Access Compliance Report

Public Rights-of-Way

(Curb Ramps)

Intersection ID: N/A	Main Street: PAISLEY_ABBEY_LN	Cross Street: KELBURN_LN	Location: NE
ADA ID: 325B113D0595	Ramp Type: BlendTrans1	Initial Pass/Fail: Fail	Overall Compliance: No
		Severity Score: 8.75

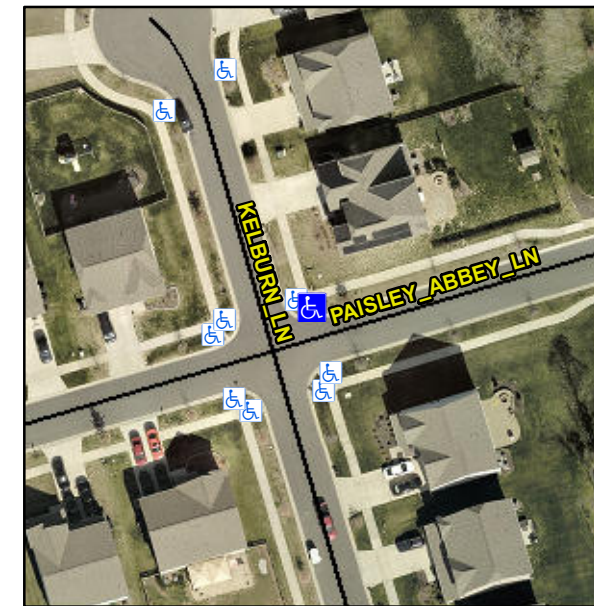
Not Found, R304.5.1

Compliance	Description	Data	Compliance	Description	Data
N/A	Ramp Length (in)	96.0	Yes	BlendTrans Slope (%)	3.9
No	Ramp Width (in)	44.5	Yes	BlendTrans XSlope (%)	0.1
N/A	Flare Type LT	N/A	N/A	Flare Type RT	N/A
N/A	Flare Slope LT (%)	N/A	N/A	Flare Slope RT (%)	N/A
N/A	Flare Traversable LT?	N/A	N/A	Flare Traversable RT?	N/A
N/A	Landing Length (in)	N/A	N/A	DWS Provided?	N/A
N/A	Landing Width (in)	N/A	N/A	DWS Contrast?	N/A
N/A	Landing Slope (%)	N/A	N/A	DWS Length (in)	N/A
N/A	Landing X Slope (%)	N/A	N/A	DWS Full Width?	N/A
N/A	Landing Curb? (Y/N)	N/A	N/A	DWS Offset (in)	N/A
N/A	Shared Landing?	N/A			
N/A	Gutter Ponding?	N/A	N/A	Gutter Slope (%)	N/A
N/A	Gutter Lip Ht (in)	N/A	N/A	Gutter X Slope (%)	N/A
N/A	Painted X Walk1?	No	N/A	Painted X Walk2?	N/A
	X Walk 1 Direction	To SE		X Walk 2 Direction	N/A
	X Walk 1 Width (in)	N/A		X Walk 2 Width (in)	N/A
	X Walk 1 Slope (%)	3.5		X Walk 2 Slope (%)	N/A
	X Walk 1 X Slope (%)	0.8		X Walk 2 X Slope (%)	N/A

N/A	Ramp inside XWalk1?	N/A	N/A	Ramp inside XWalk2?	N/A
	Road Slope (%)	0.8		Clear Space?	N/A
	Road X Slope (%)	3.5	N/A	Clear Space to XWalk (in)	N/A
N/A	Any Obstructions?	N/A	N/A	Storm Grate/Utility Hazard?	N/A
	Obstruction Type			Storm Grate/Utility Type	
		N/A			N/A
			Yes	Surface Condition? (G/P)	Good
			No	Curb Slope (%)	9.1

Remove & Replace Curb Ramp With Two New Directional Ramps or Equivalent.
